PLANNING AND ZONING CASE CHECKLIST

P&Z CASE # SP2019-005 P&Z DATE 2/20/19 CC DATE 3/12/19 APPROVED/DENIED _____
ARCHITECTURAL REVIEW BOARD DATE _____ HPAB DATE _____ PARK BOARD DATE _____

Project Number: SP2019-005
Project Name: Saddle Star South
Project Type: SITE PLAN
Applicant Name: SADDLE STAR LAND DEV. LLC
Owner Name: R, & R HANCE INVESTMENTS LP
Project Description:

Project Number	SP2019-005	Owner	R, & R HANCE INVESTMENTS LP	Applied	2/19/2019	LM
Project Name	Saddle Star South	Applicant	SADDLE STAR LAND DEV. LLC	Approved		
Type	SITE PLAN			Closed		
Subtype	PD			Expired		
Status	P&Z HEARING			Status	2/21/2019	DG

SADDLE STAR SOUTH
PLANT LEGEND

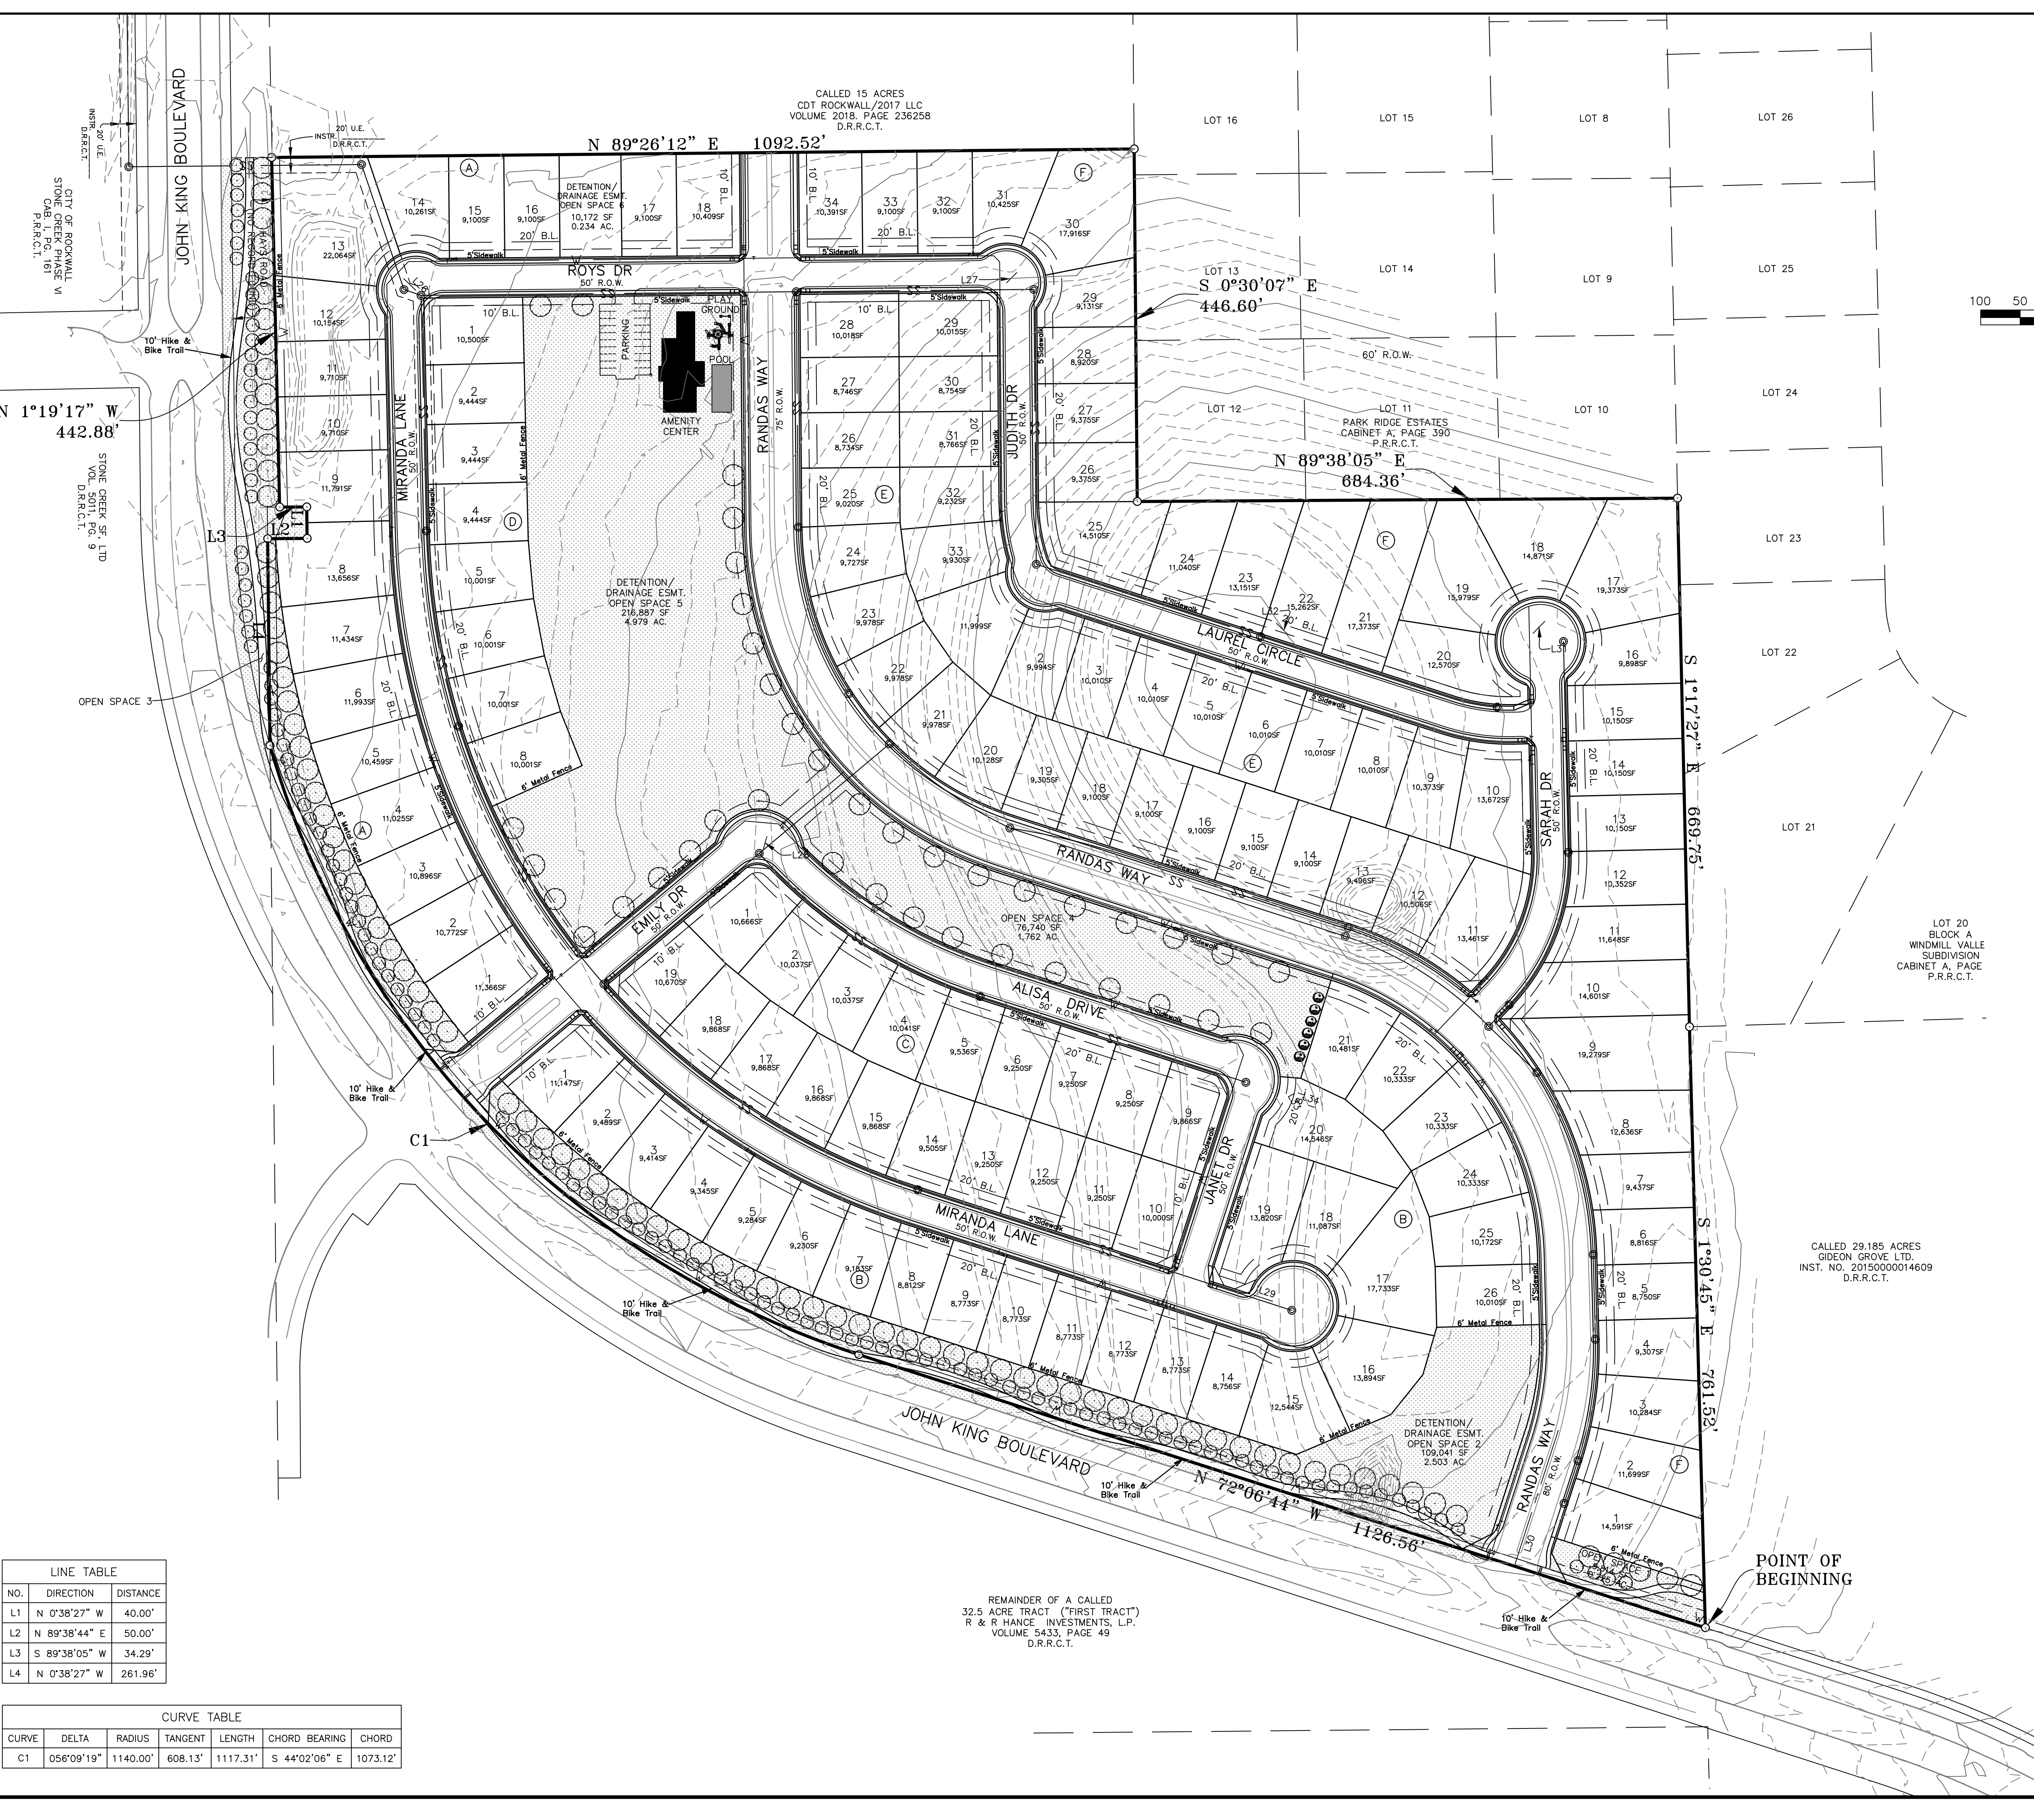
1. Update tree legend by providing a list of tree types that are approved in Ord No. 16.39						
2. Provide all other landscape materials (i.e. type, species, etc.) being used within development.

3. Delineate and label 50-ft landscape buffer along John King Blvd						
4. Built-up berm or shrubs or both? Indicate on plan to match PD Site Plan

5. Based on the number of inches being removed and the number of inches provided on site, the mitigation is considered to be satisfied pending approval of the Planning and Zoning Commission.

2 7'-0" STONE COLUMN AND 6'-0" ORNAMENTAL METAL FENCE
ELEVATION

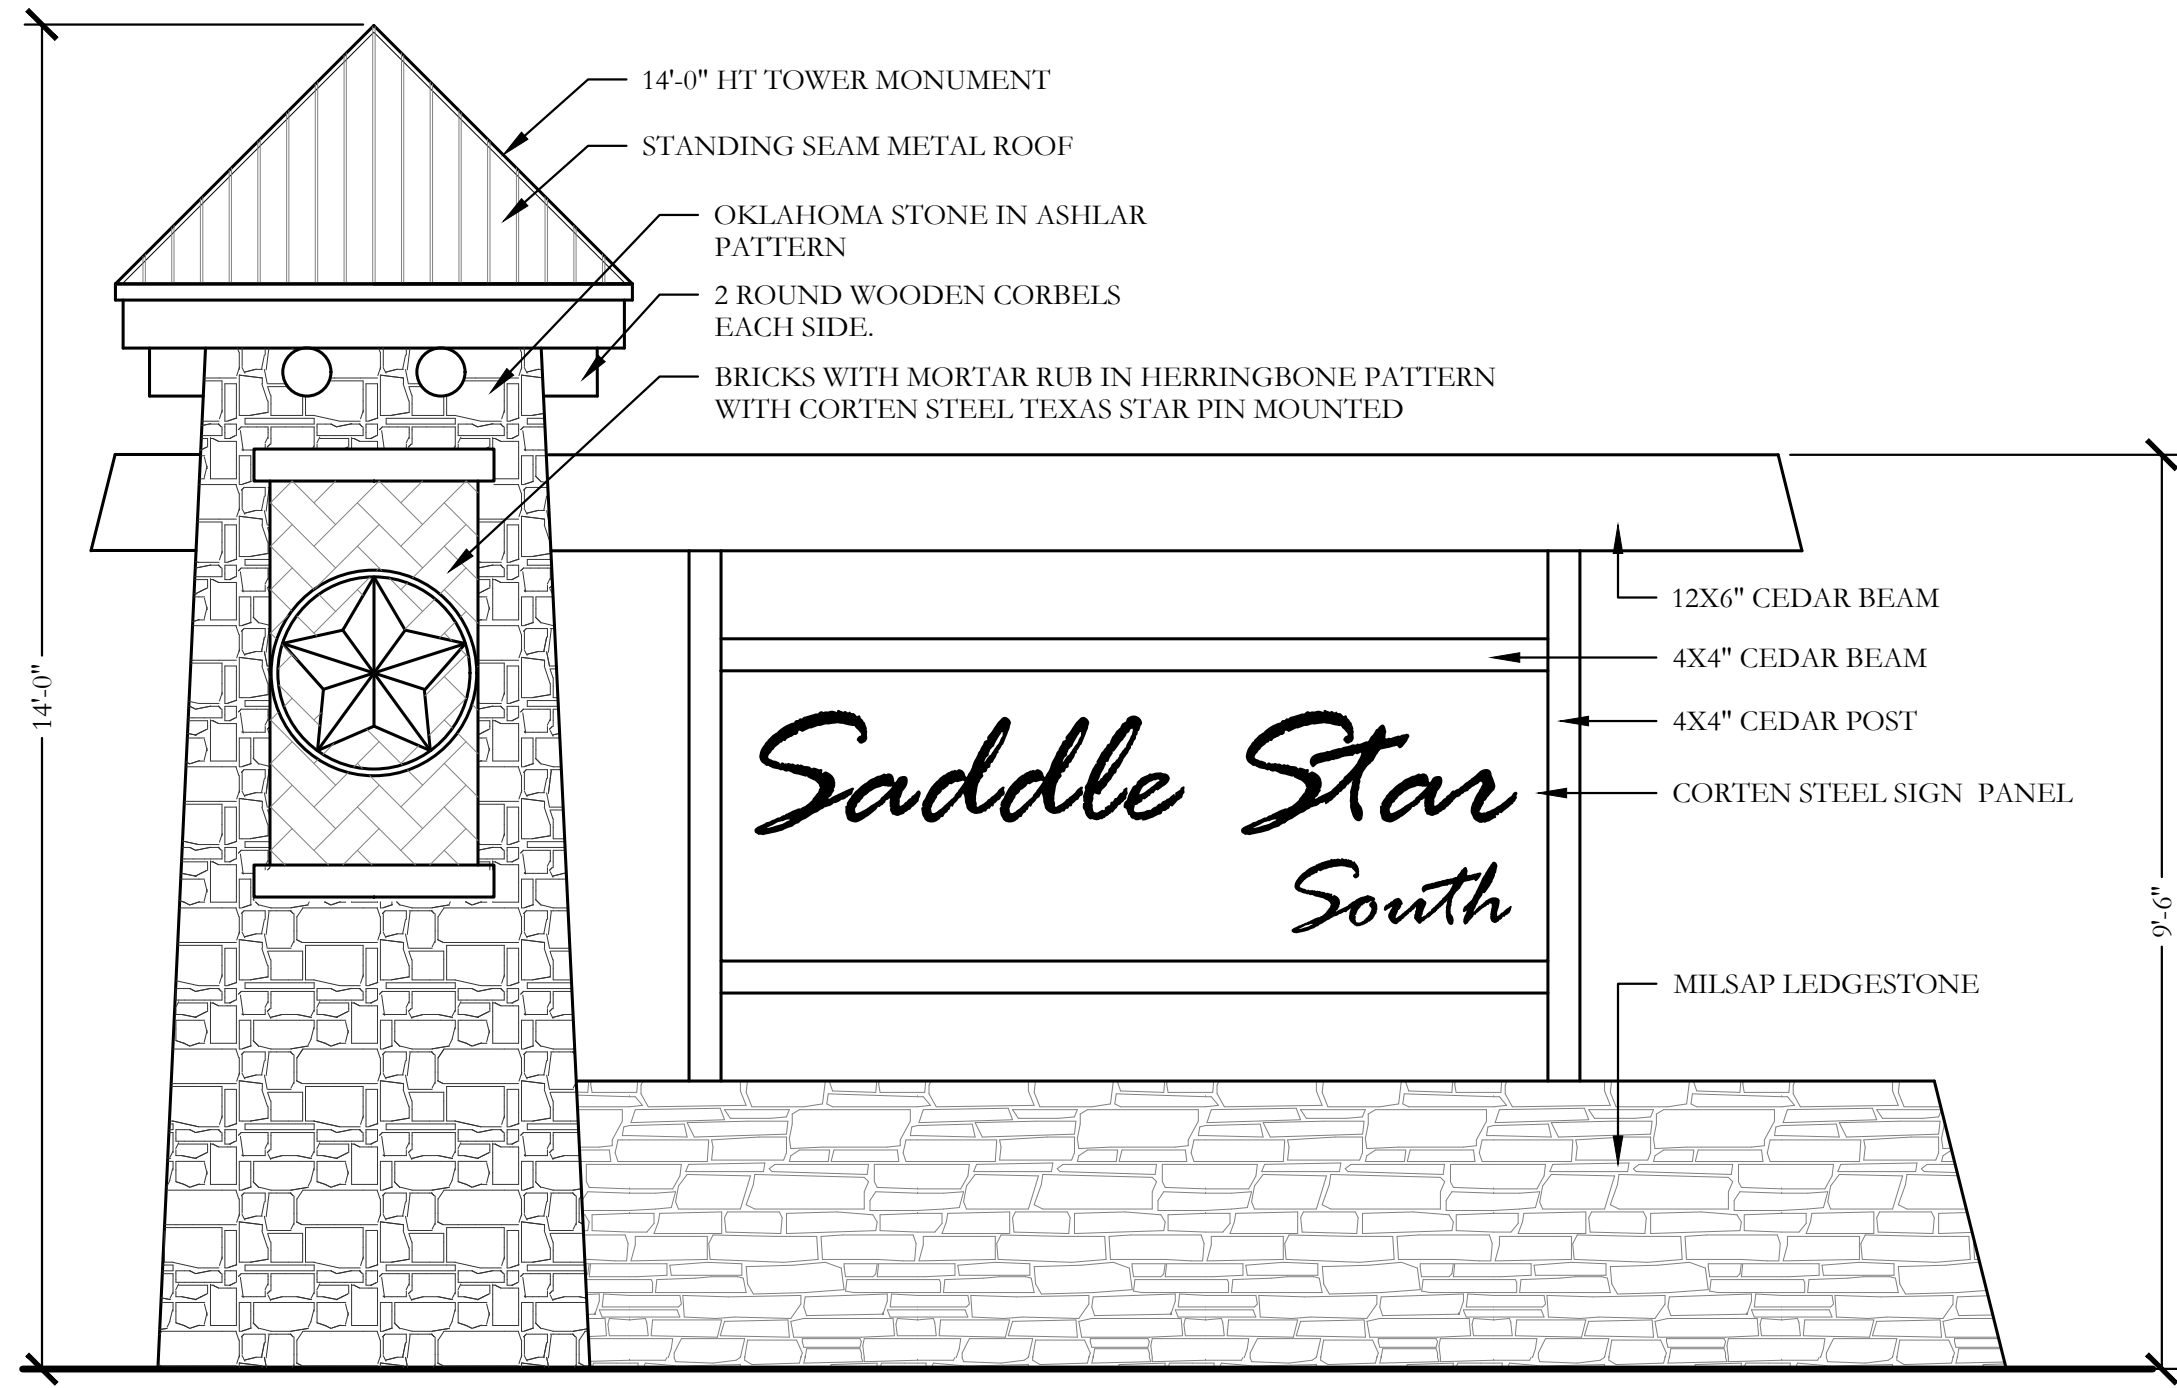
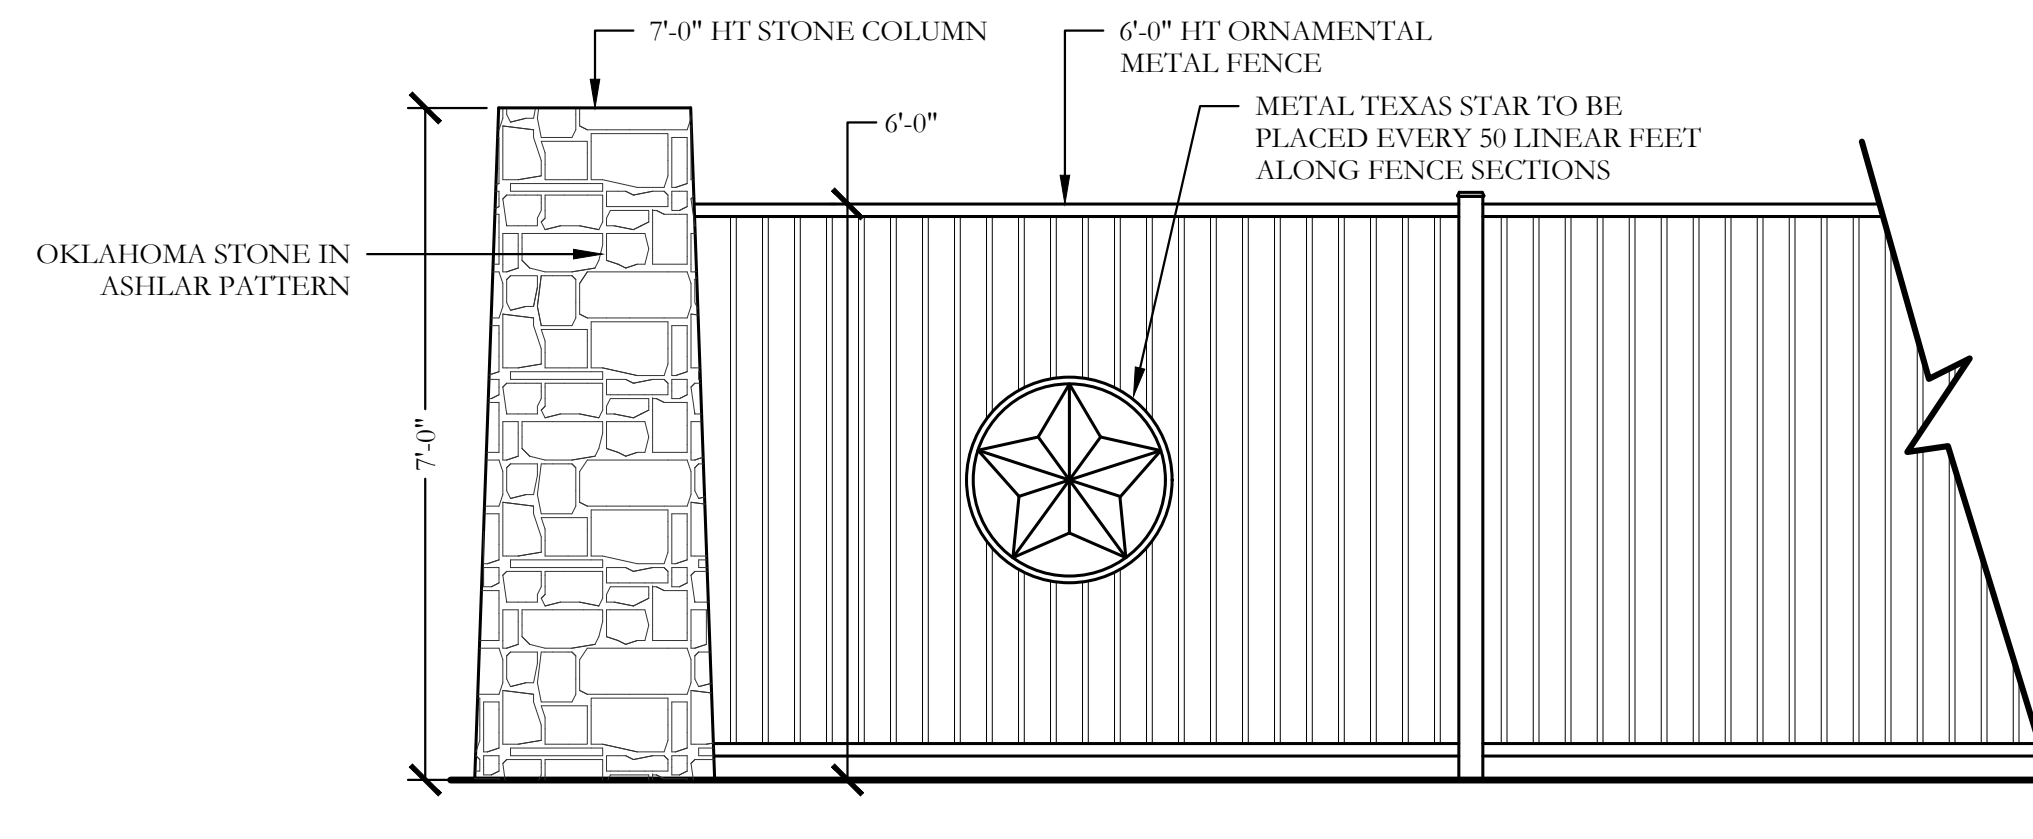
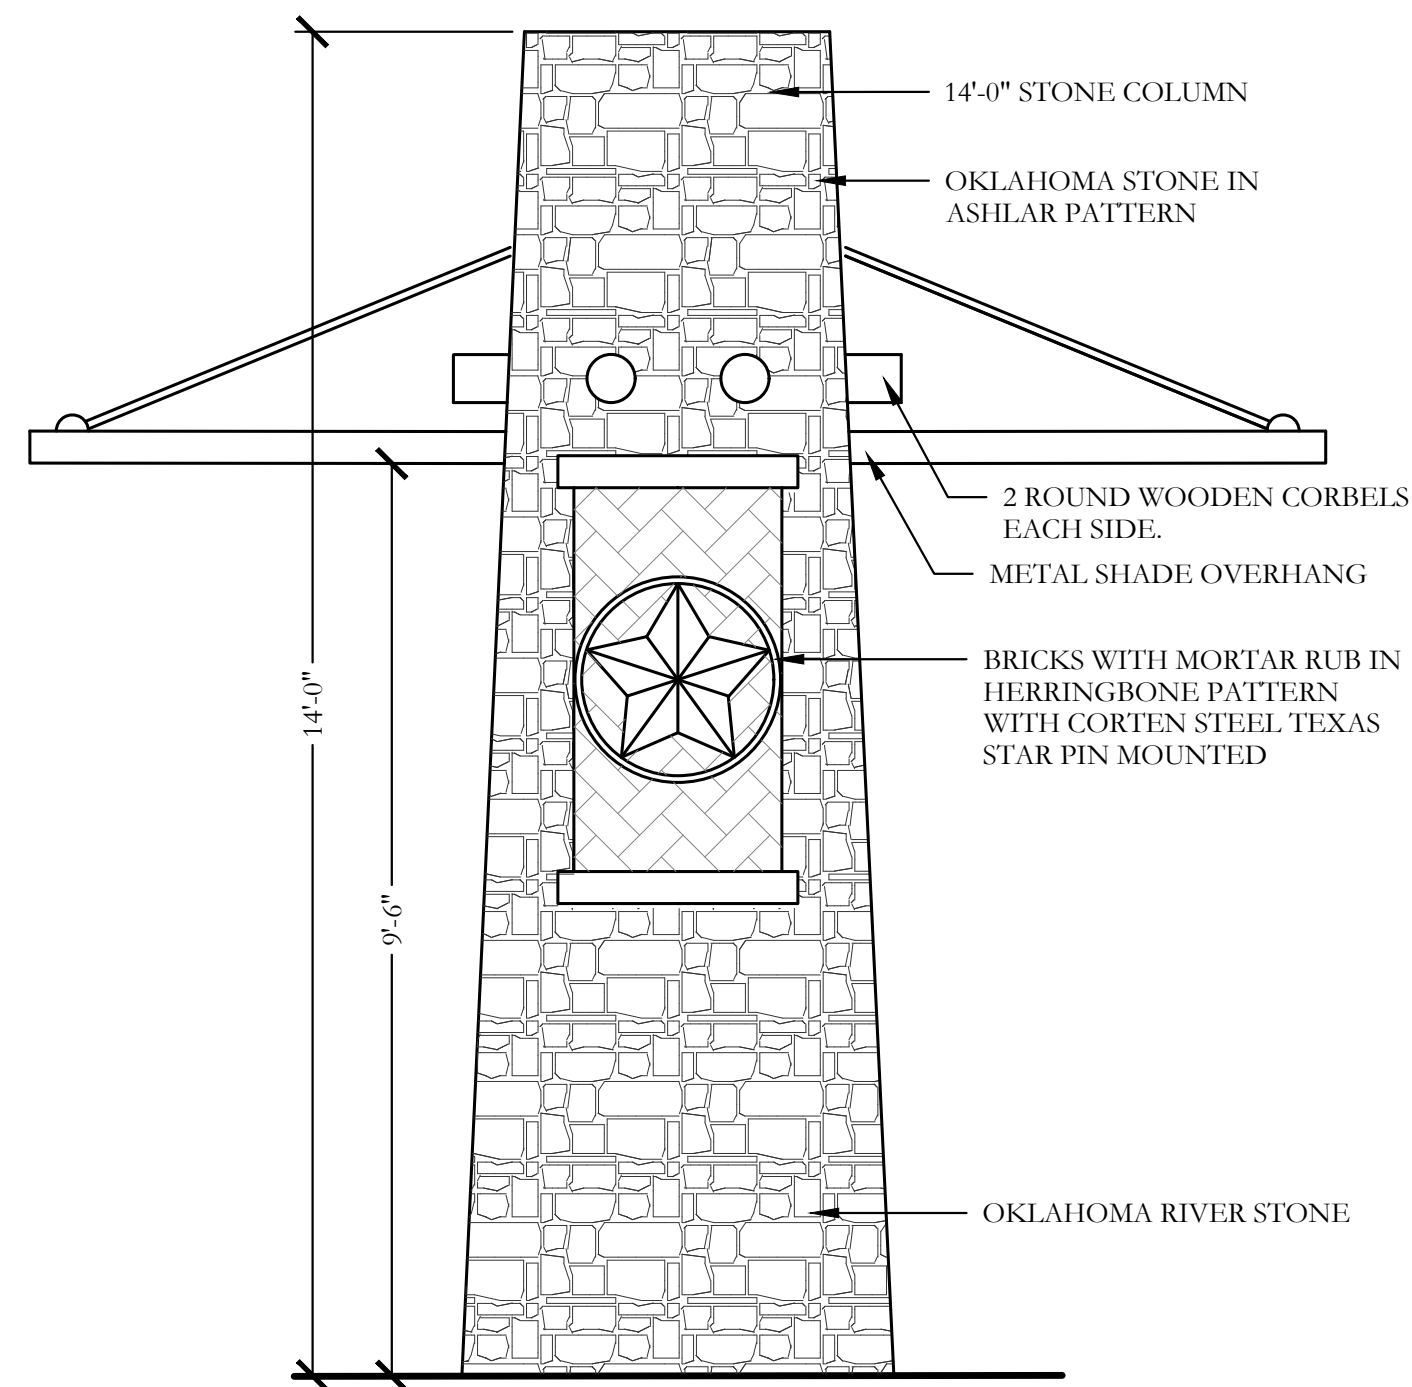
3. Fence detail needs to indicate wrought iron or tubular steel fencing materials Fence columns to be spaces at 45-ft O.C.						
4. Street names to match PD Site Plan. Names to be approved by the GIS Department (Lance Singleton, GIS Supervisor).						
Landscape/Treescape Plan:
